86130A-07

S E R V I C E N O T E

86130A BitAlyzer Error Performance Analyzer

Intermittent “Whitescreen” display on instrument startup.

Solution/Action:**MOD #4 POWER DISTRIBUTION BOARD****(1) Removal of U2****(2) Jumper PIN#1 to PIN#14 (20-gauge wire)**

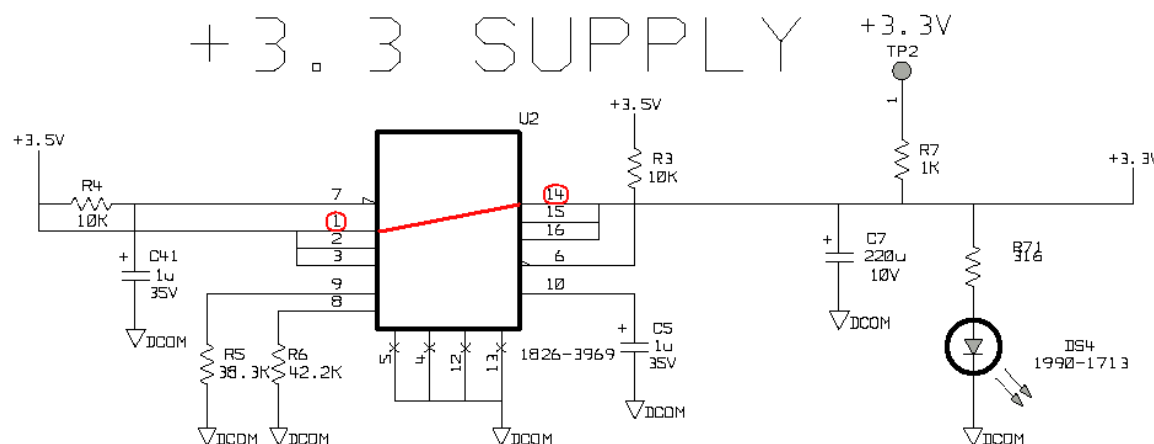
On boot-up only, the 86130A instrument display may intermittently appear “white” and will not display any graphics. This can be caused by U2 (+3.3V HotSwap Power Manager PN1826-3969) on the A1A2 Power Distribution Assy (86130-60001 RevA) interrupting the 3.3V supply if transient current exceeds its set limit. It has been determined that the 3.3V breaker to the A5A1 CPU Board is not required since it is not capable of drawing more than 4A of current (per the CPU vendor). On an average unit it never exceeds 3A.

- 4) Remove the instrument cover and locate the A1A2 86130-60001 Power-Dist. Assembly.
 - 5) Using side-cutters carefully (as to **not** dislodge PCB traces) cut each of the 14 legs on U2 (Agilent PN1826-3969, MFG PN UCC3918) Hot-Swap Manager integrated circuit.

- 6) Using a soldering iron, carefully remove the remaining legs from the printed-circuit-board assembly.
 - 7) Clean any excess solder off of the remaining fourteen pads of U2.

- 8) Using a #20-gauge wire, bridge the PIN#1-to-PIN#14 pad. Leave no excess wire over the ends of the two pads!
- NOTE: USE THIS SPECIFIC WIRE SIZE !**

- 9) Solder the wire on either end to the two pads.
 - 10) Test this MOD by reinserting the power-plug and powering the BERT to the “powered-on” state.
 - 11) If the instrument powers on and the display comes on then the modification verification was successful. Attach a “MOD 4” label between “Connector P4 and the Lambda DC-DC convertor module”.
